Addendum 01

PROJECT: Zane Grey Intermediate School MVHC Clinic Renovation
968 Pine Street
Zanesville, Ohio 43701

PROJECT #: 25006.02

This addendum form is a part of the Contract Documents and modifies the Bidding Documents titled "Construction Documents," dated June 17, 2025, with amendments and additions noted below.

2 AHU-1 ELEVATION AND PLAN VIEW DETAIL
M3.1 NTS

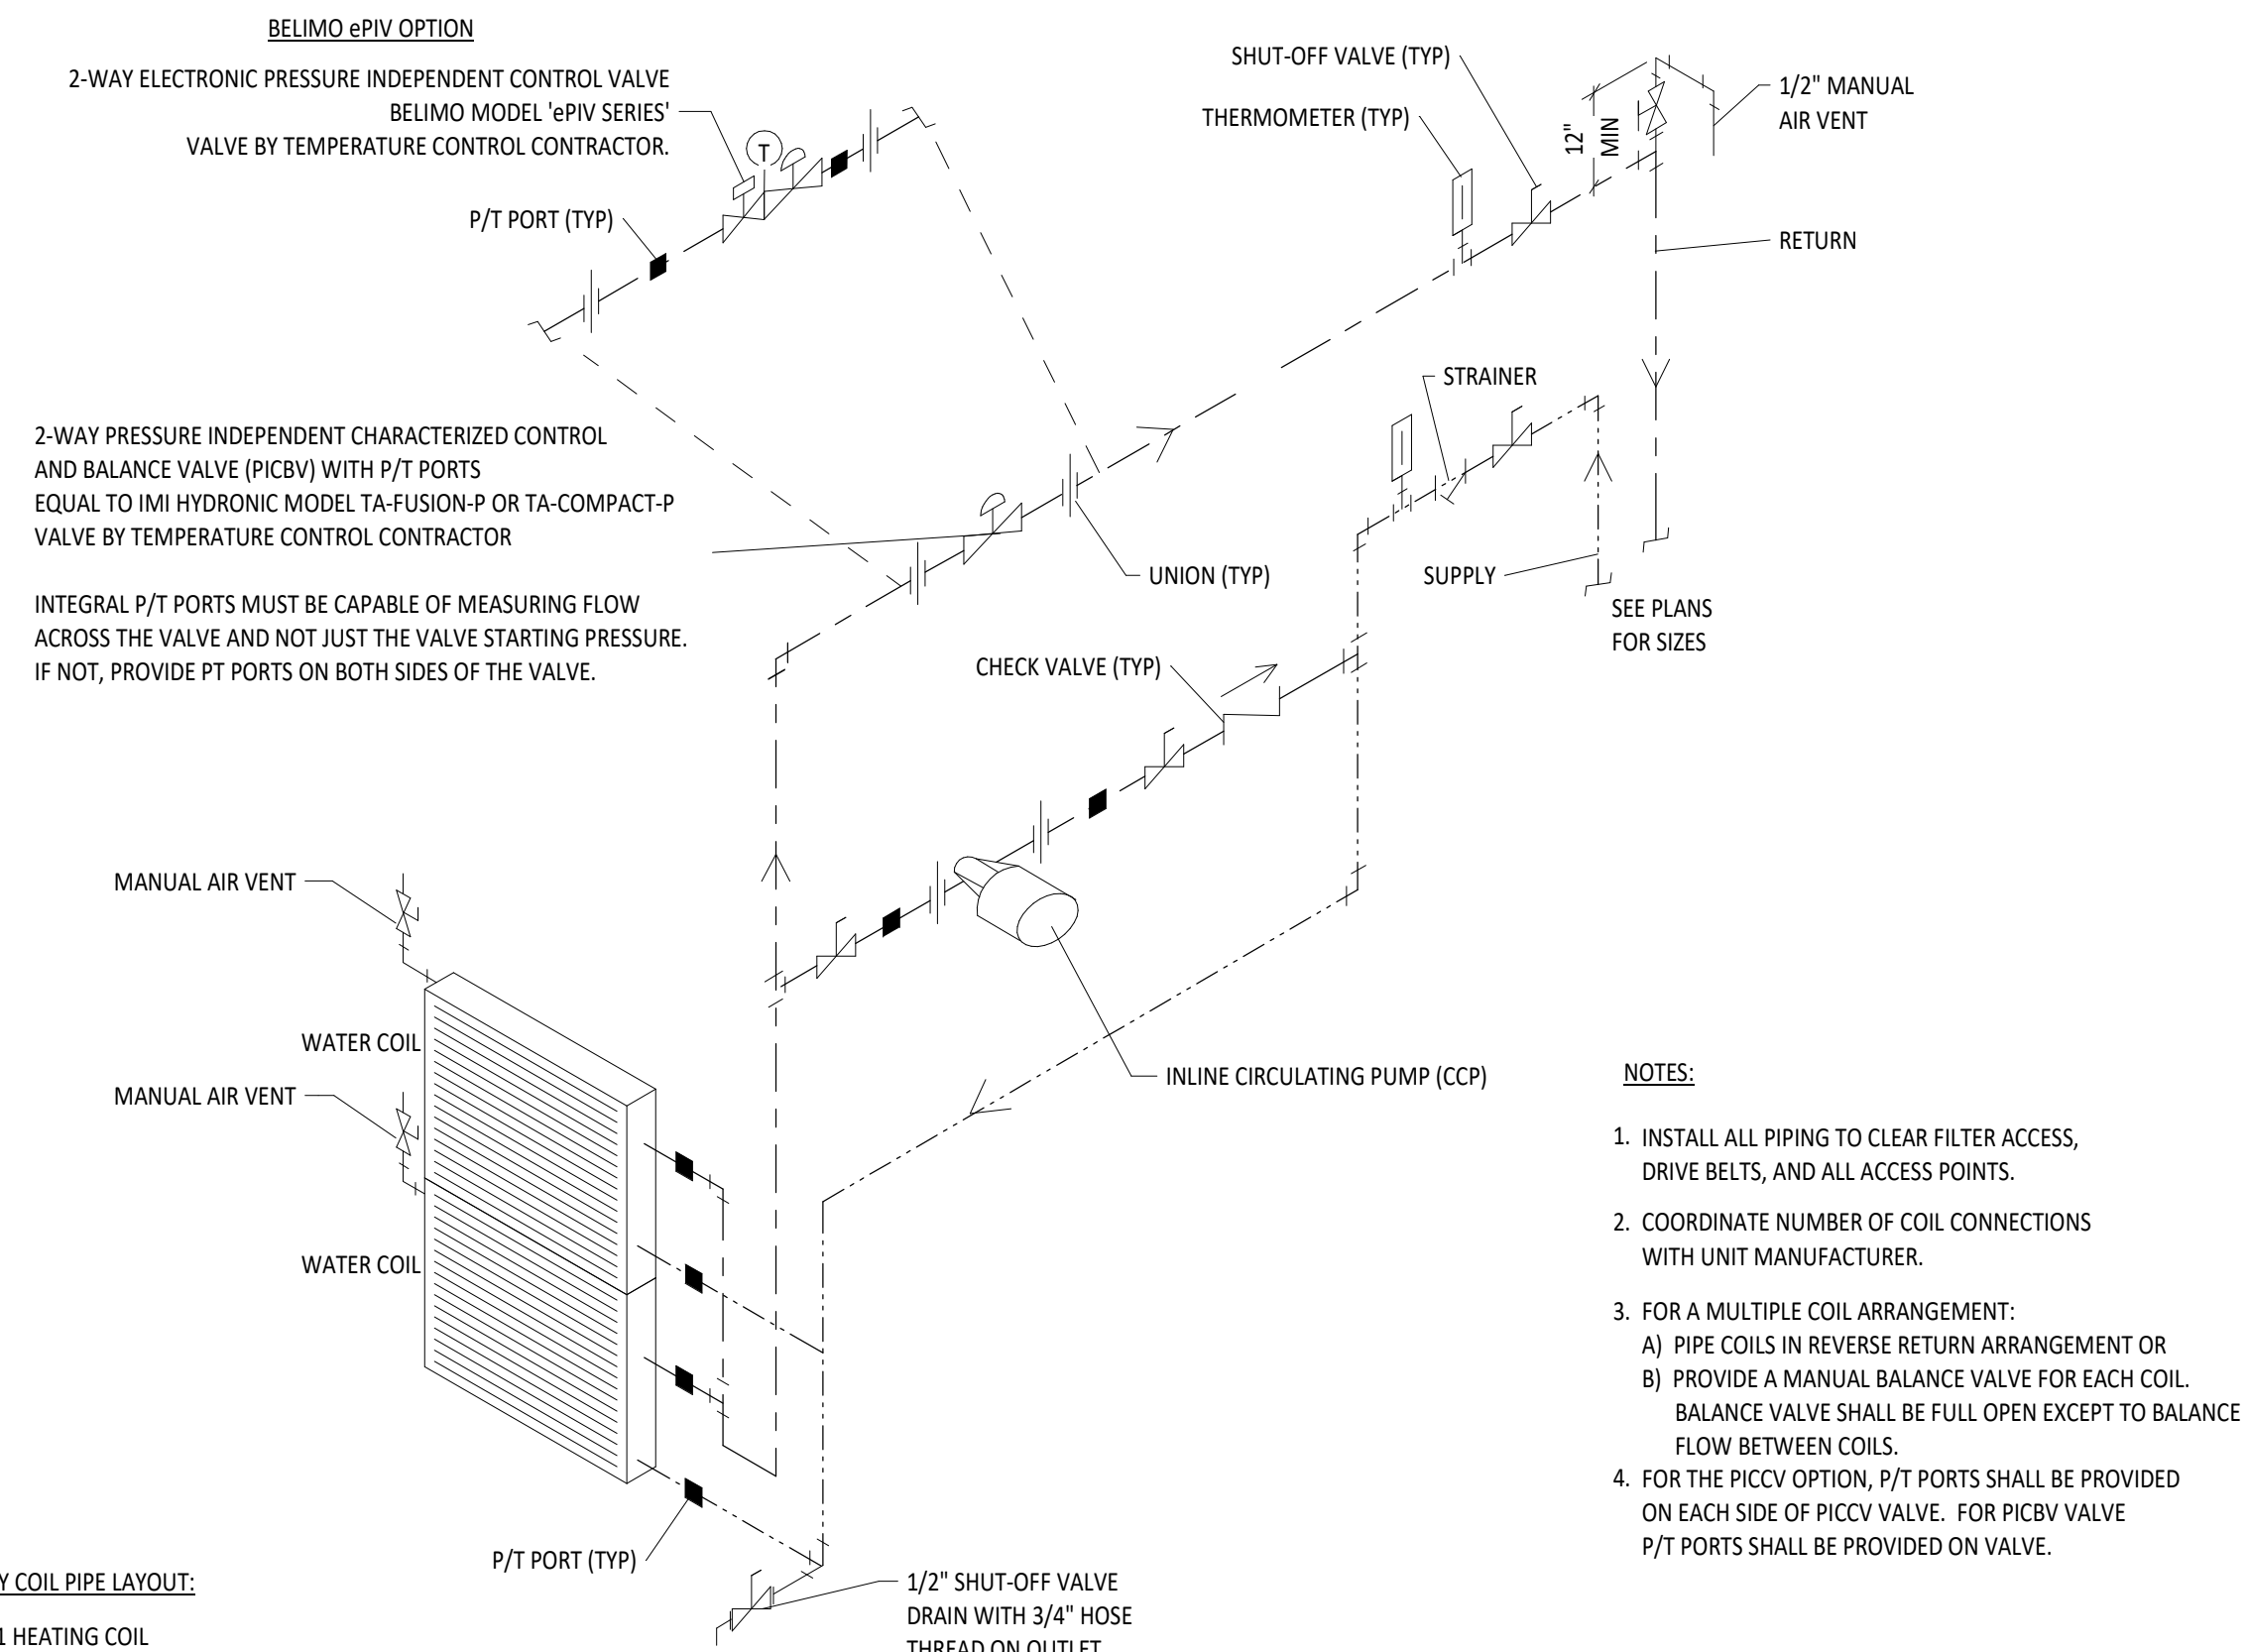
- a. Updated AHU detail
 - b. Updated AHU Control detail
 - c. Revised tagging of piping plan
5. Drawing Sheet E2.1 Electrical Plans: Detail 3 First Floor Power Plan – Unit A:

3
E2.1
FIRST FLOOR POWER PLAN - UNIT A
1/8" = 1'-0"

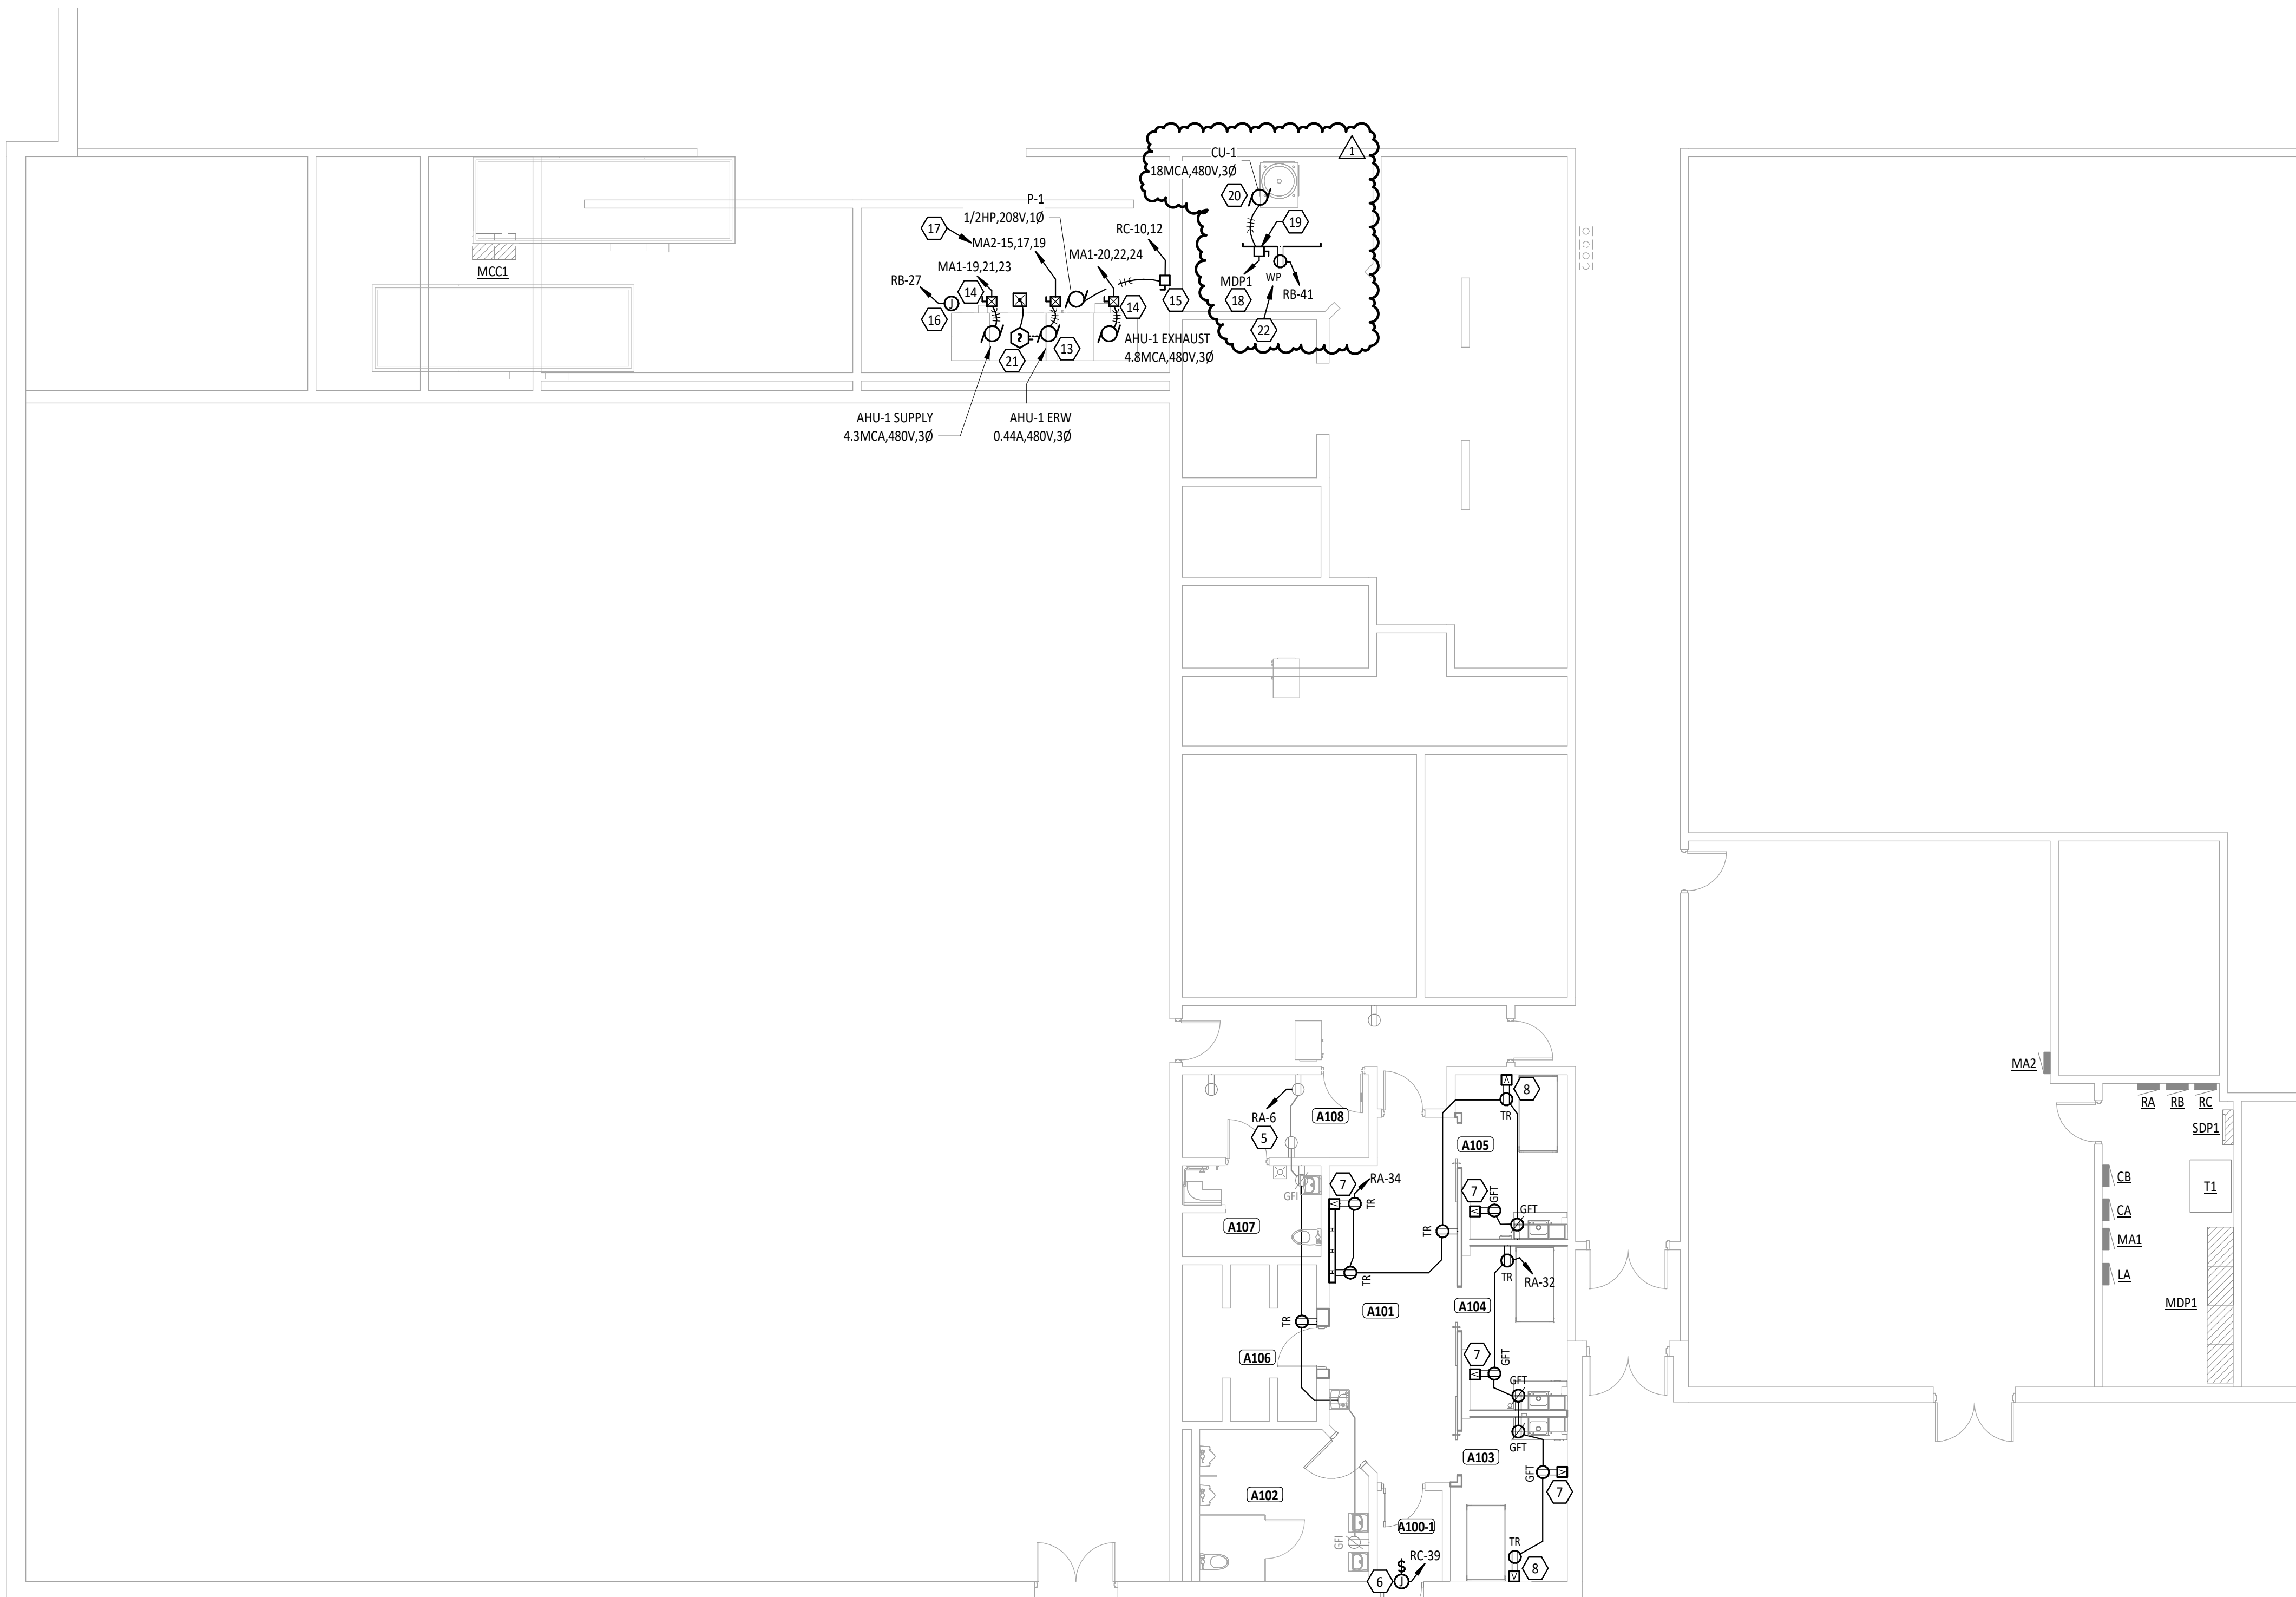
- a. Removed electrical connections associated with CU-2 from roof.
6. Drawing Sheet E3.1 Electrical One-Line Diagram and Schedules: Detail 1 Electrical One-Line Diagram:

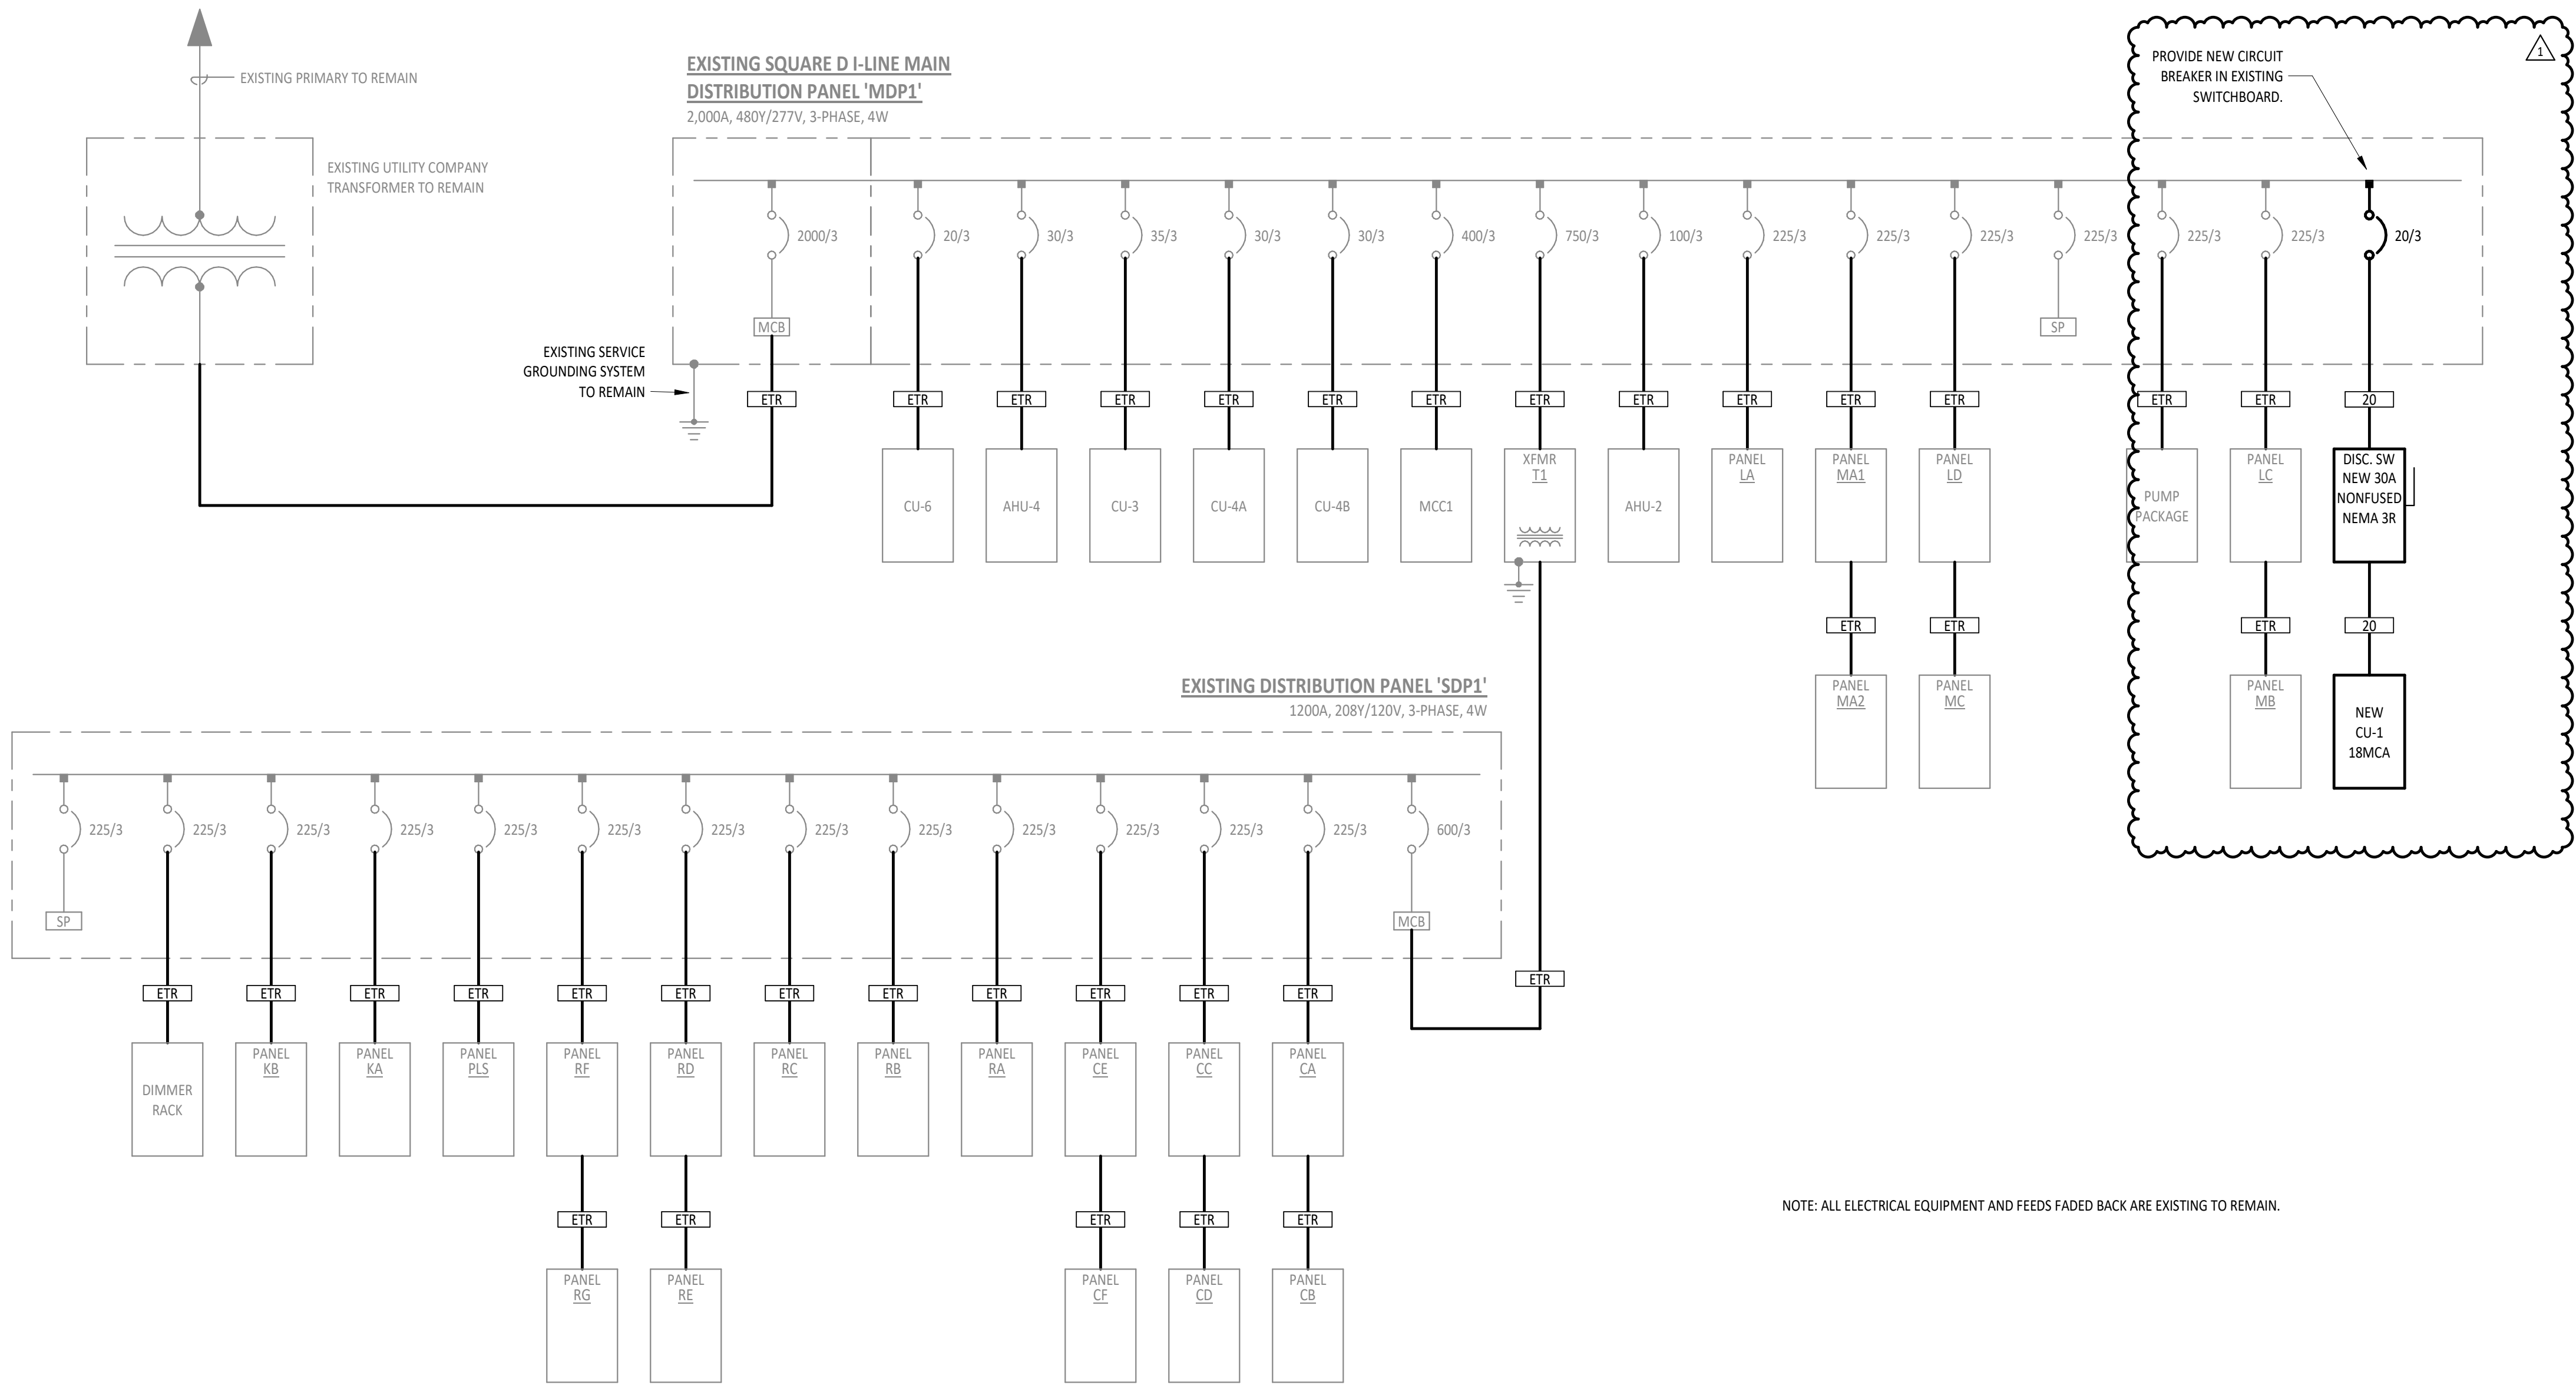
- a. Remove electrical connections and equipment associated with condensing unit CU-2 and change overcurrent protection for condensing unit CU-1 to 20A.
